CITY OF PHILADELPHIA

# Evaluation of the Chestnut Street Art Shelters

**August 21, 2017**

**Re: Condition assessment and treatment recommendations for the 12<sup>th</sup> Street Bus Shelter Artwork**

## **Assessment by Northeast Fence & Iron Works, Inc:**

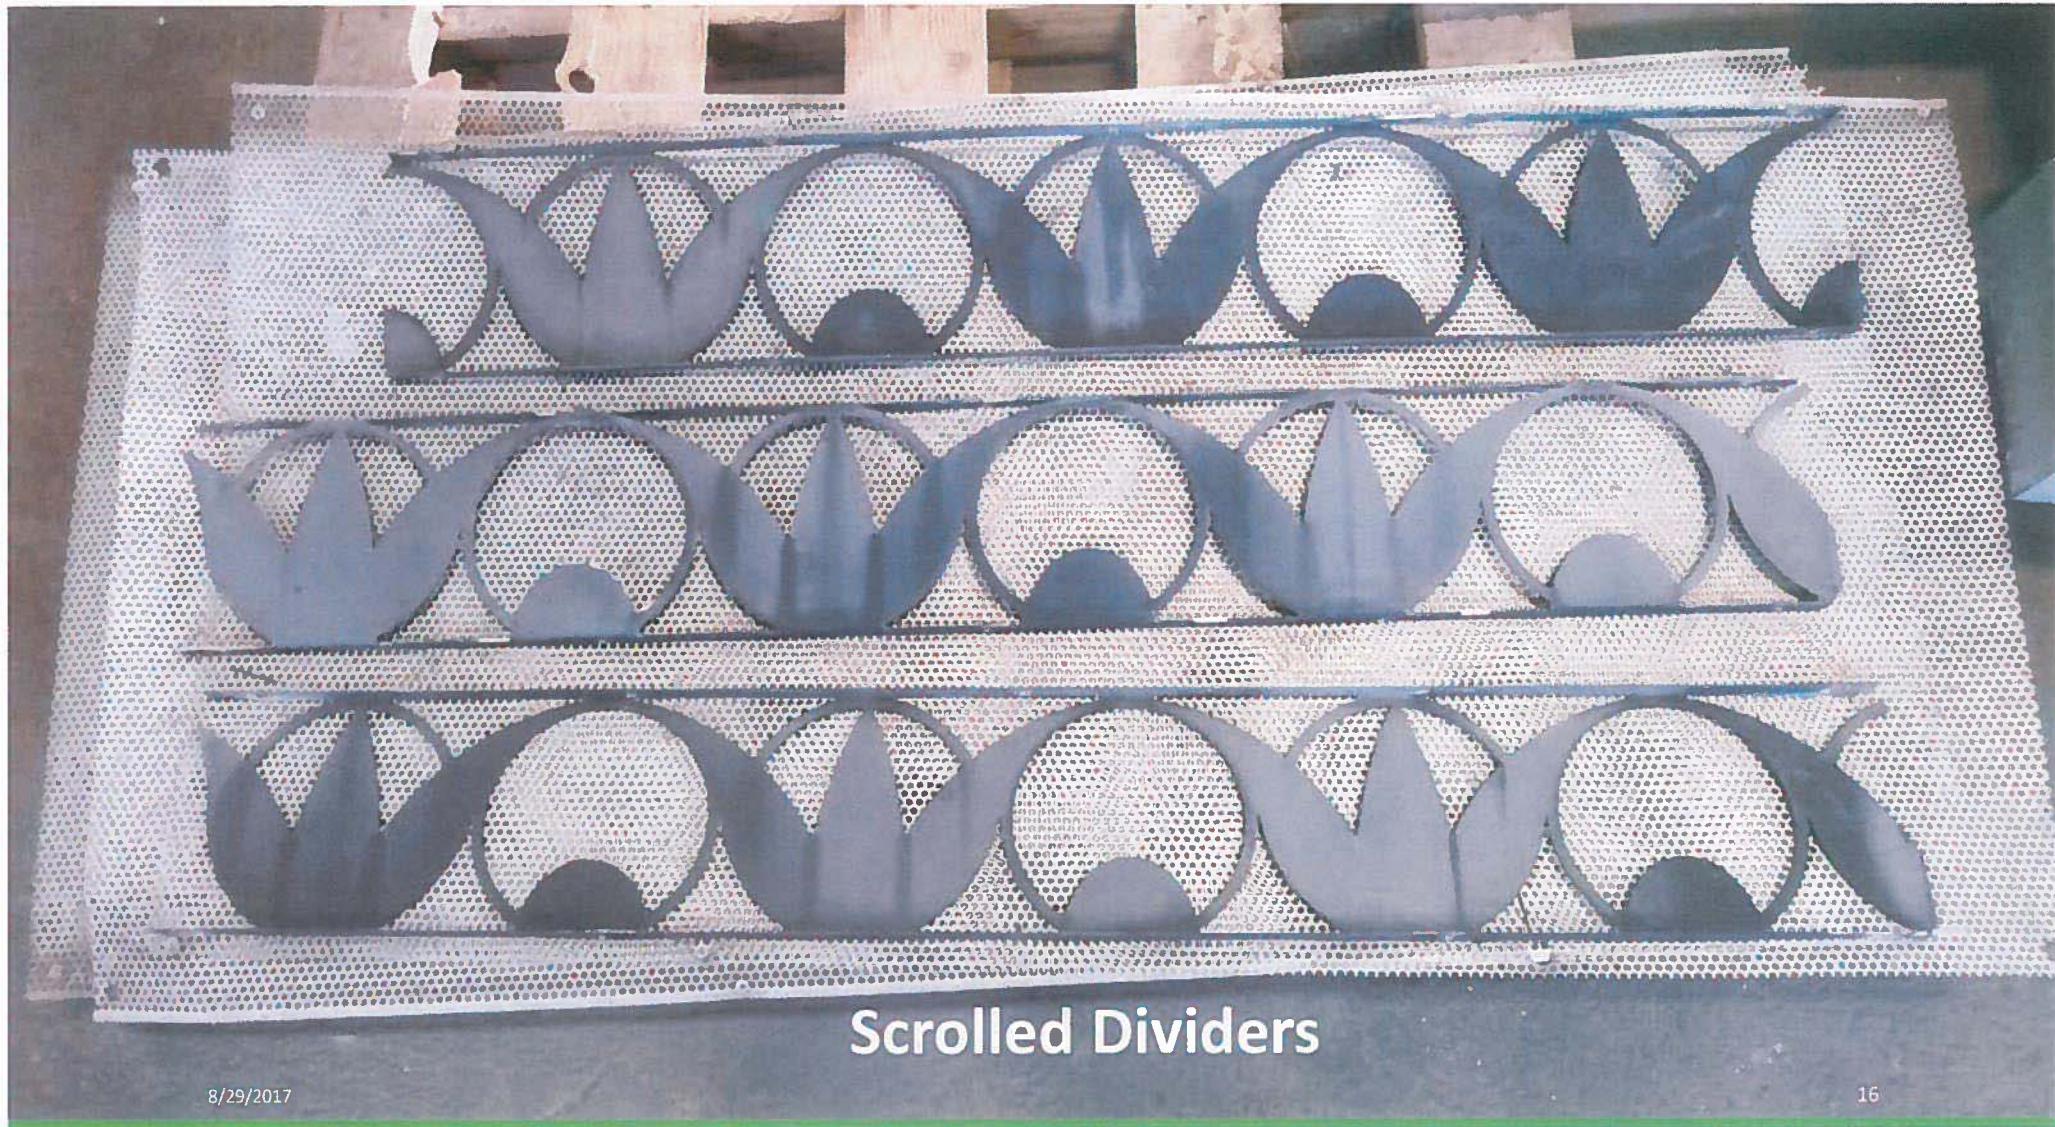
**Condition of the shelter  
structure after Disassembly:**

***Severe Rusting of base leg support  
columns***

***Rusting of weep  
holes allowed for  
water and debris  
to fill legs***

***Severe Rusting of stained glass panel  
support beam***

*“The main support structure should be replaced due to rusting...”*

**Conclusion: The corrosion of the base beam could lead to failure of the beam. The failure of the beam would leave the 250-300 lb mosaic art panel unsupported. The risk associated with the beam failure and art panel destabilization is a public safety hazard.**

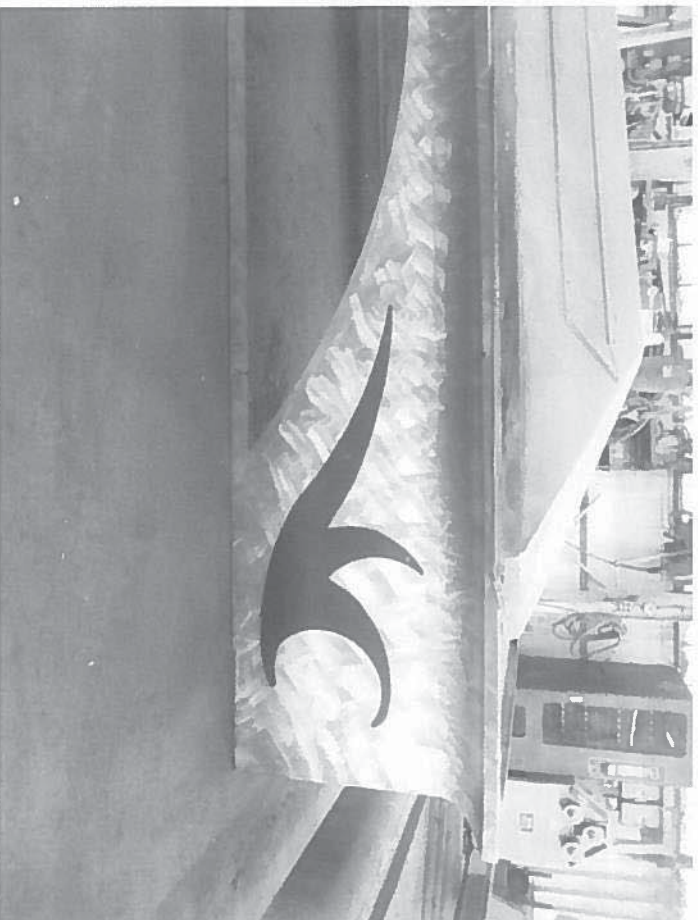
**Condition:** The artwork is in generally good condition. The sealant at the joints between the bus shelter structure and the art work has failed. The east base rail of the structure exhibits corrosion where it intersects with the panel, the result of moisture becoming trapped at this location.

**Treatment:** Install drainage weeps between the panel and the bottom rail of the structure. Prior to reinstalling the artwork, clean all old deteriorated sealant from the edges of the artwork and the structure and install new sealant.

*Fanlight – note the discoloration due to soiling at the base*

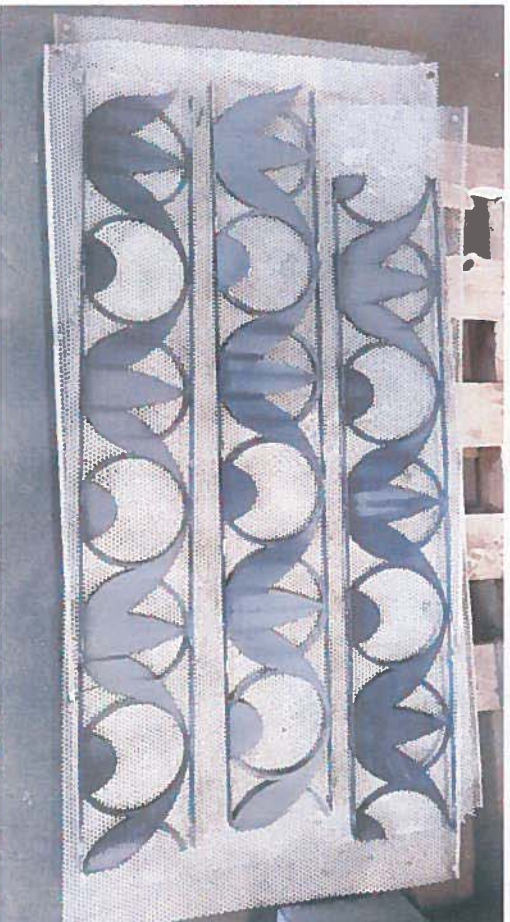
**Condition:** The glass and embedment material are soiled. The glass is cracked in some areas, but this appears to be an intentional aesthetic.

**Treatment:** Clean soiling from the glass and the embedment material.
